CASE: T3-2017-9874

RE: Application for a Conditional Use for a road spoils disposal site (Case T3-2017-9874)

Attached are the additional materials requested for the Coopey Quarry road spoils disposal site permit application requested by your letter dated January 4, 2018. Below are the summarized requested items and ODOT's response.

**Revised April, 18, 2018**

Figure 4. Coopey Quarry restoration concept.

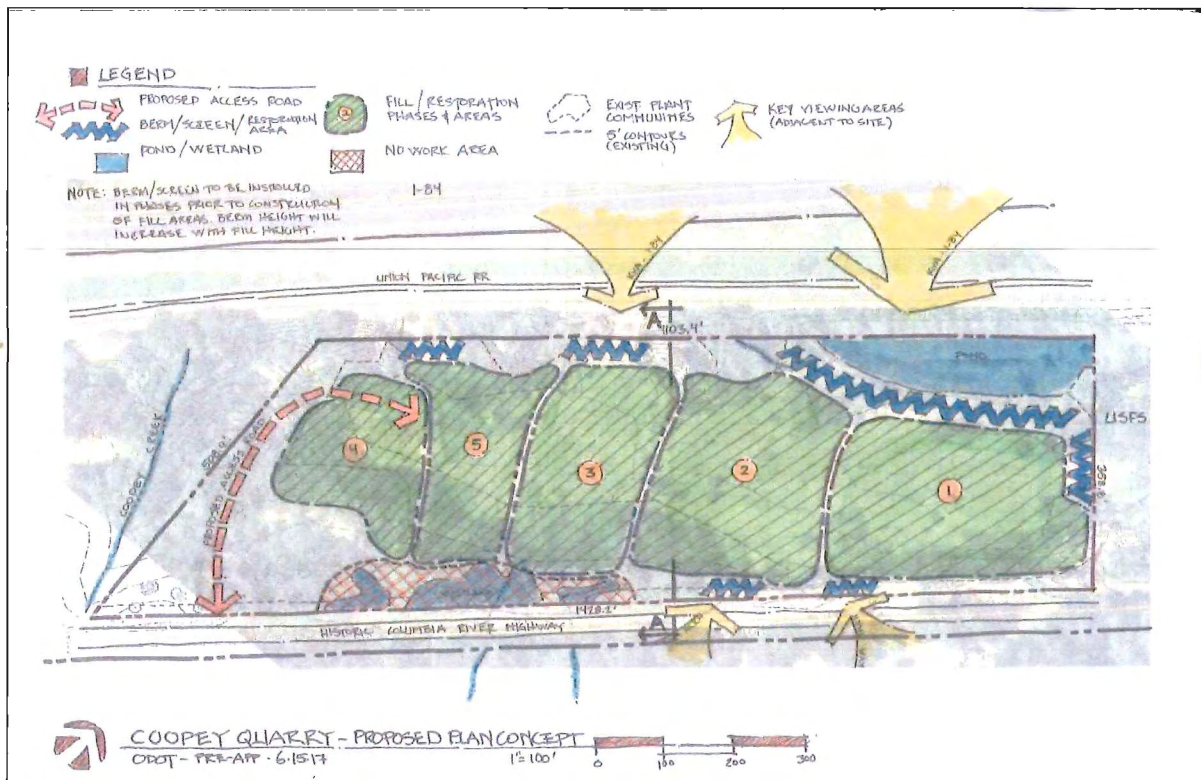
2. Revise the narrative and mitigation plan to address mitigation for the buffers around the wetlands and pond buffer. *The Mitigation Report (Appendix E) has been updated with the requested information, and the narrative in the code response table has been amended to be consistent. The new Mitigation Report Revised in March 2018 should replace the original Mitigation Plan from November 8<sup>th</sup>.*

The Coopey Creek Disposal Site Reclamation Plan (**Appendix A**) will start with planting berms along I-84. These initial berms are designed to hide disposal activity from I-84 travelers. The berms will be planted on the north slopes with native tree species shortly after construction. Other initial restoration activities will include removal of English Ivy and Himalayan blackberry from the retained buffers.

ODOT will restore the quarry site continuously as it gets filled. ODOT proposes to fill the quarry from the east to the west in phases (Figure 4). We are anticipating about five phases that create cells within the disposal site. The berms along I-84 will be increased as the cells are filled. When a cell is completely filled, it will be restored with a foot of topsoil, compost and native forest plantings. When the final phase is complete and the cell is filled, ODOT will remove the access road and replant the access route.
